General Electric Company
Nuclear Energy Report
MDE-199-0985-NP, Rev. 1

Susquehanna - 1
Steam Dryer Vibration
Steady State and Transient Response

SUSQUEHANNA - 1 STEAM DRYER VIBRATION STEADY STATE AND TRANSIENT RESPONSE

Acceptance Comment 1

Figure 5 - Main Steamline Pressure as a Function of Power

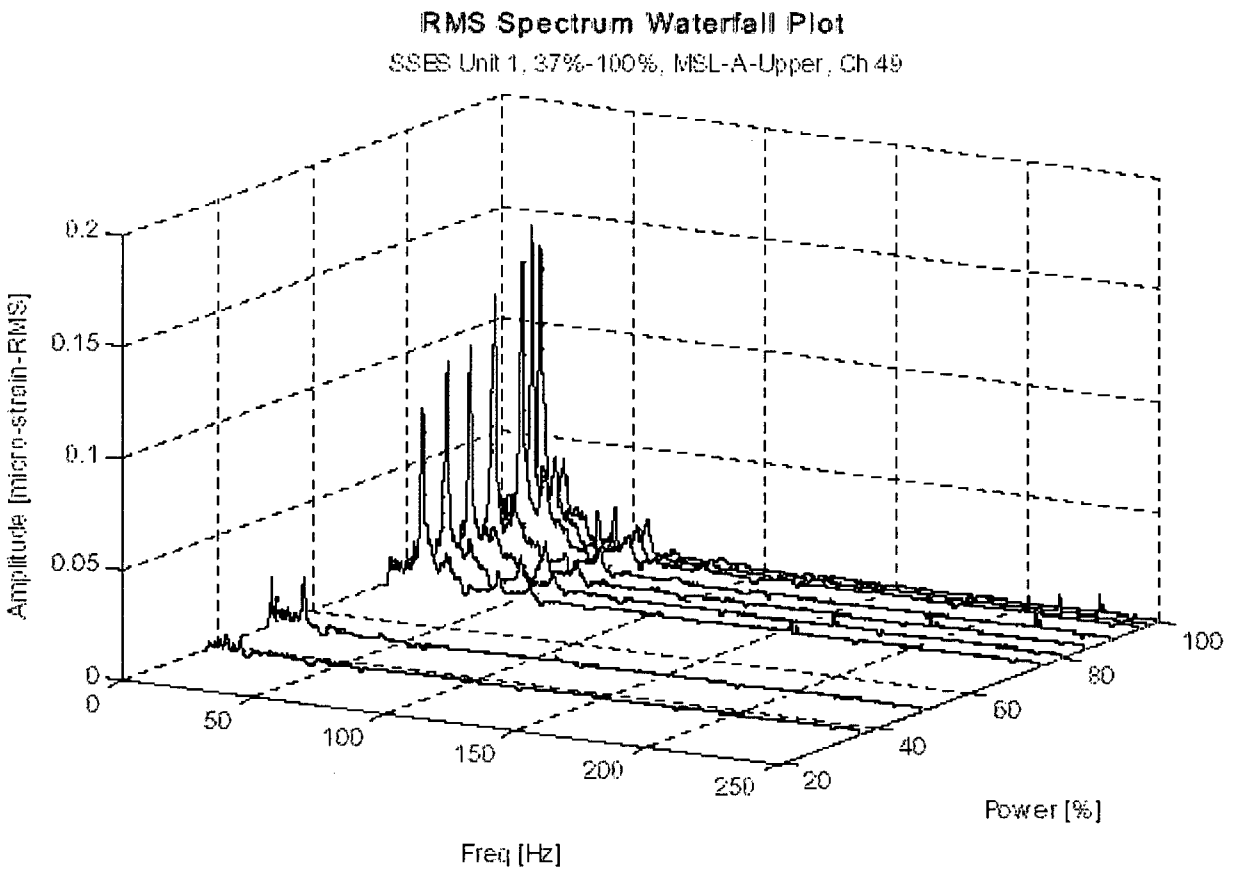
The licensee's submittal indicates the presence of a strong spectral peak at about 110 Hz in the SSES 1 and 2 plant measurements on the steam dryer. The licensee should discuss the source of this peak and the absence of its prediction in the analysis.

The frequency of the observed panel resonance matches the recirculation pump vane passing frequency corresponding to the core flows and recirculation pump speeds present when the measurements were made. The 110 Hz peak observed in the second bank hood panel strain gauge measurements is due to a local structural resonance in the panel where strain gauges S4 and S5 were located. The dryer panels are responding to a strong vibration response in the recirculation loop piping that is excited by the recirculation pump vane passing frequency. The piping vibration is transmitted through the vessel to the dryer supports. This recirculation piping vibration response was first observed in SSES Unit 2 when the plant entered the Increased Core Flow (ICF) region for the first time following licensing of the ICF region.

The recirculation pump vane passing frequency matched a structural mode of the panel at the core flow conditions when the measurements were taken (110 Hz at 100% OLTP and 113 Hz at 90% OLTP). The 110 Hz response was noted at that time of the measurements, as determined in MDE-199-0985-P, Revision 1, which is provided as Appendix 1 of this letter. At that time, the source of the resonance was not investigated. Structural analyses in MDE-199-0985-P, Revision1 determined that the 110 Hz frequency was a structural mode of the second panel. These conclusions were confirmed by performing a vibration analysis using the current whole dryer finite element model. The fatigue evaluation presented in Attachment 10 considered flow-induced vibration resulting from pressure loads applied directly to the dryer. Because the 110 Hz vibration load was transmitted mechanically through the dryer supports, it was not predicted in the pressure load Flow Induced Vibration (FIV) analysis presented in Attachment 10 of PPL's CPPU submittal.

Figures 2 and 3 show the frequency spectra for the second bank strain gauges for power levels from 70% to 100% OLTP. In Attachment 10, a scaling factor was developed in order to adjust the predicted stress results from the finite element analysis to be equivalent to the stresses indicated by the in-plant dryer instrumentation. The scaling factor was based on a comparison of the predicted strains to the measured strains for S4 and S5 at the 100% OLTP power case where the 110 Hz peak is the highest. As discussed above, the 110 Hz peak shown in Figures 2 and 3 were correlated to the recirculation pump vane passing frequency. Because this dominant peak is based on the

recirculation pump vane passing frequency and a local structural resonance, a stress under prediction factor based on it will be bounding for the other power levels. Without the 110 Hz peak, the stress under prediction factor would be approximately 30% lower. The rest of the frequency spectrum is proportional to steam flow during the power ascension. The pressure loads, as shown by the pressure drum (Figure 4) and steam line pressure measurements (Figure 5) are also proportional to steam flow as power increases. If the 110 Hz peak were not present, a scaling factor based on the measured strain gauge response would be relatively constant as power increased. Strain gauges S4 and S5 were located on the second bank panel near the high stress location where the weld seam cracked during the first cycle. It is most likely that the 110 Hz peak is a local structural resonance in this panel caused by the vibrations introduced by the recirculation pump vane passing frequency. The structural performance of the dryer over more than 20 years suggests that there are no other locations on the dryer that are experiencing high stresses as a result of the recirculation pump vane passing vibration.
